Docket Number:	12-AFC-03
Project Title:	Redondo Beach Energy Project
TN #:	201383
Document Title:	Data Response Set 1A 8, 10, 13, 20-24
Description:	N/A
Filer:	Sarah Madams
Organization:	CH2M HILL
Submitter Role:	Applicant Consultant
Submission Date:	12/6/2013 2:37:37 PM
Docketed Date:	12/6/2013

Subject: Redondo Beach Energy Project (12-AFC-03)
Data Response Set 1A – Responses to CEC Staff Data Requests 8, 10, 13, 20-23

Redondo Beach Energy Project

Data Responses, Set 1A

Figure DR22-1: RBEP Total Nitrogen Deposition on Surrounding Habitats

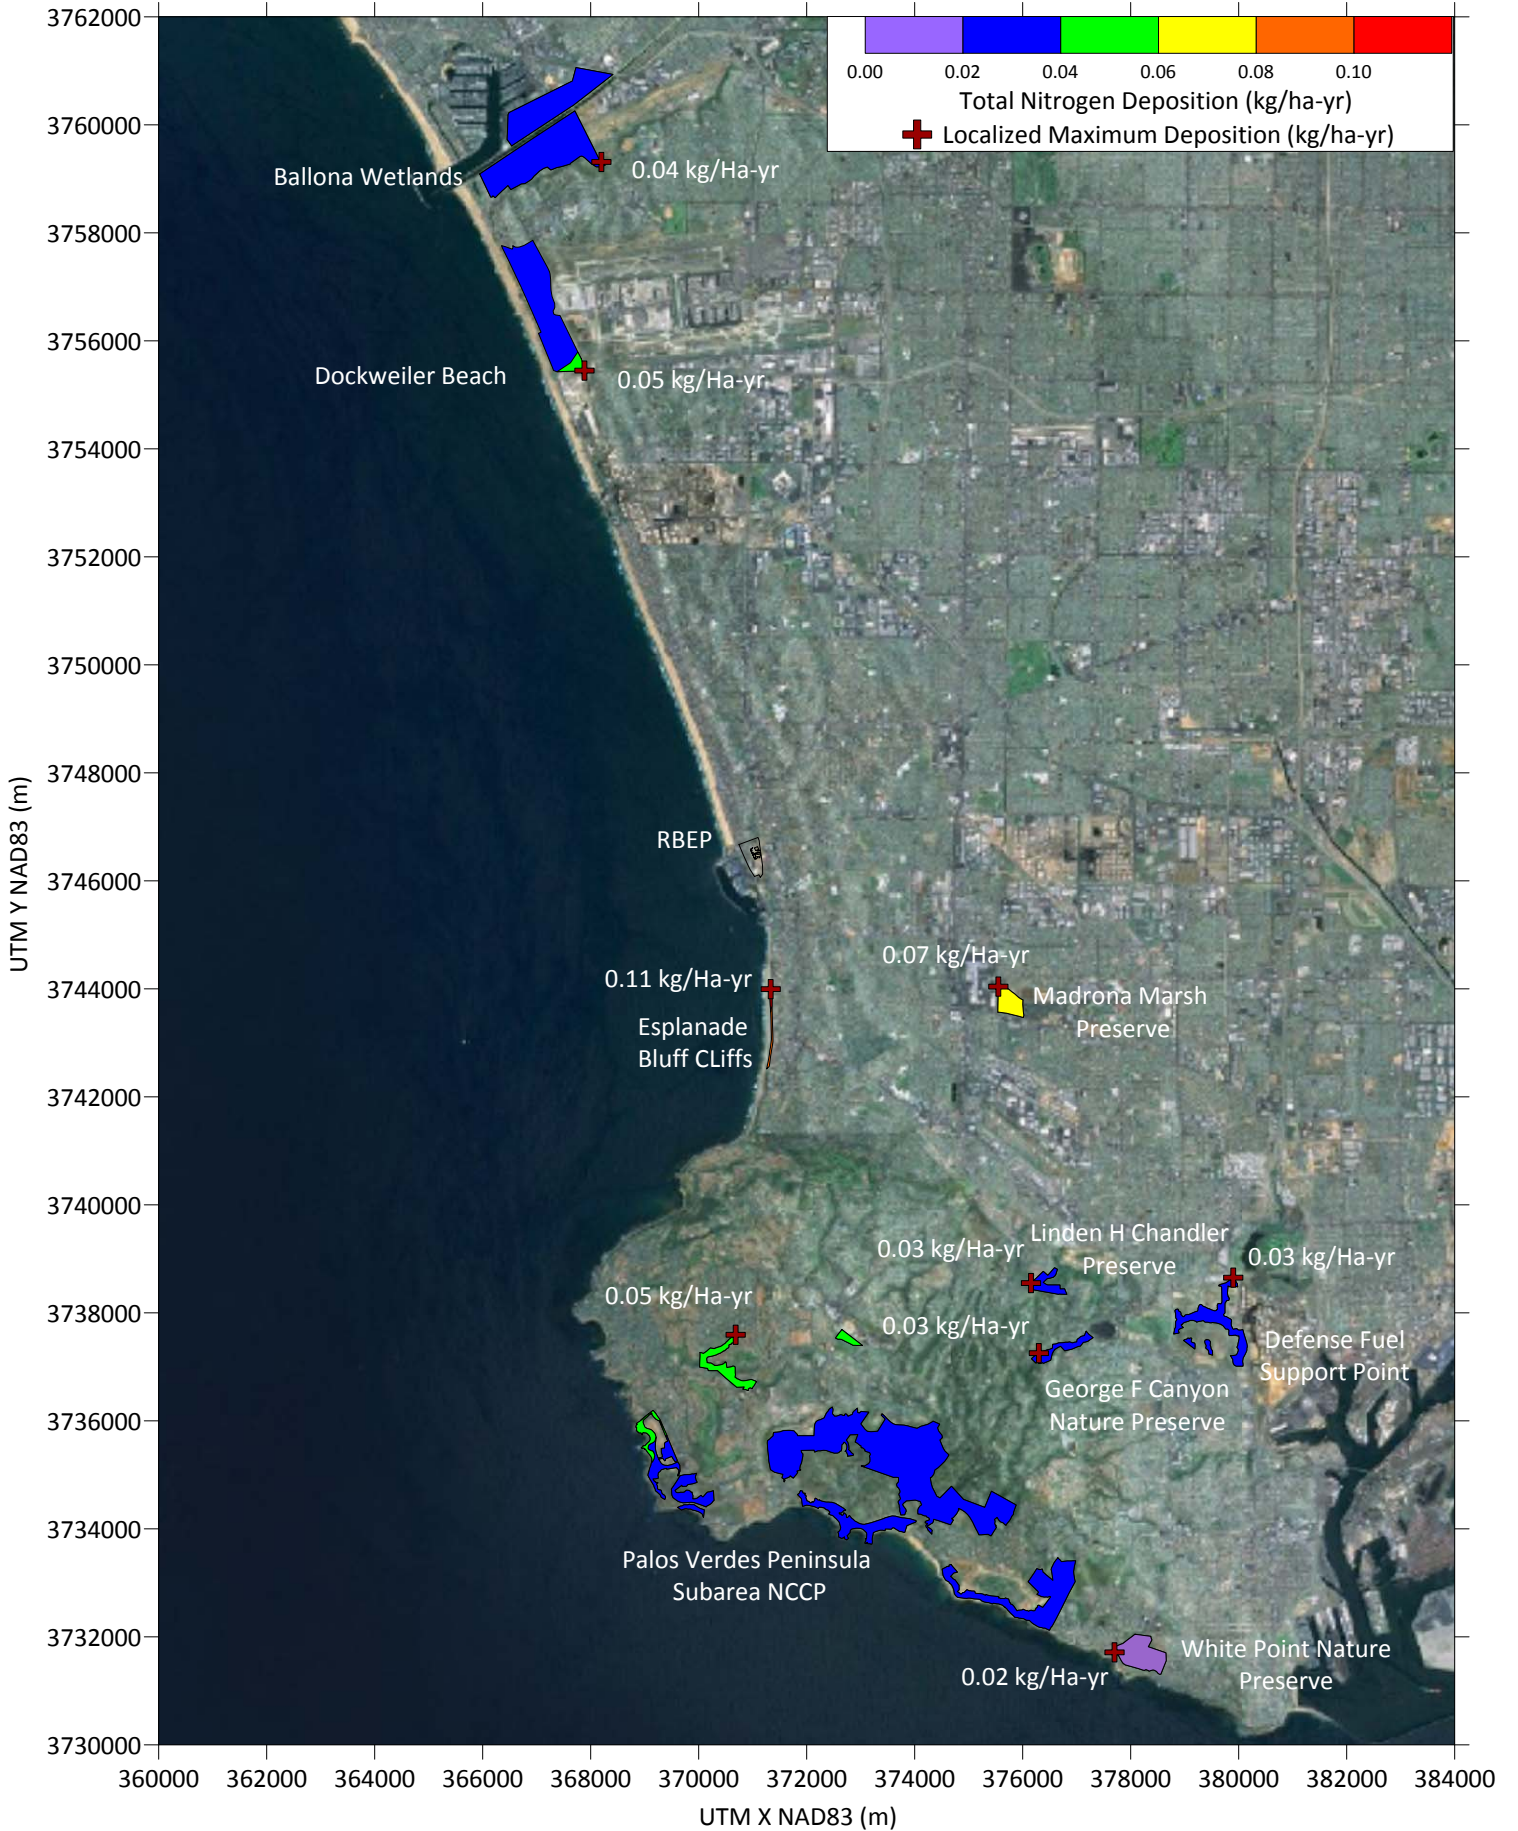
22. Please provide an isopleths graphic over the most recent aerial photographs (or equally detailed maps) of the direct nitrogen deposition rates caused by the RBEP. This will be a graphical depiction of the project's nitrogen deposition.

The AERMOD input and output files have been separately prepared and are included as Attachment DR 21-1 on compact disc. The maximum predicted nitrogen deposition and location within each of the sensitive areas are also identified in the following response to DR- 22 (see Figure DR22-1).

Response: The predicted nitrogen deposition flux isopleths are included in Figure DR22-1.

Response: As shown in Table DR20-1, the Esplanade Bluff Cliffs, where the El Segundo Blue Butterfly species was reportedly observed, belongs to the coastal dunes habitat type. Based on the response to DR- 21, as depicted in Figure DR22-1, the maximum modeled annual deposition over 5 years in the Esplanade Bluff Cliffs area was $0.11 \text{ kg-N ha}^{-1} \text{ yr}^{-1}$. When this modeled impact is combined with a conservative estimated background deposition rate of $2 \text{ kg-N ha}^{-1} \text{ yr}^{-1}$, the total predicted impact is below the CL for nitrogen deposition for the coastal dunes habitat. Because the potential effects are below the CL, no detrimental ecological effect will occur as a result from the RBEP project. As such, the impacts to the El Segundo Blue Butterfly as a result of nitrogen deposition are expected to be less-than-significant.
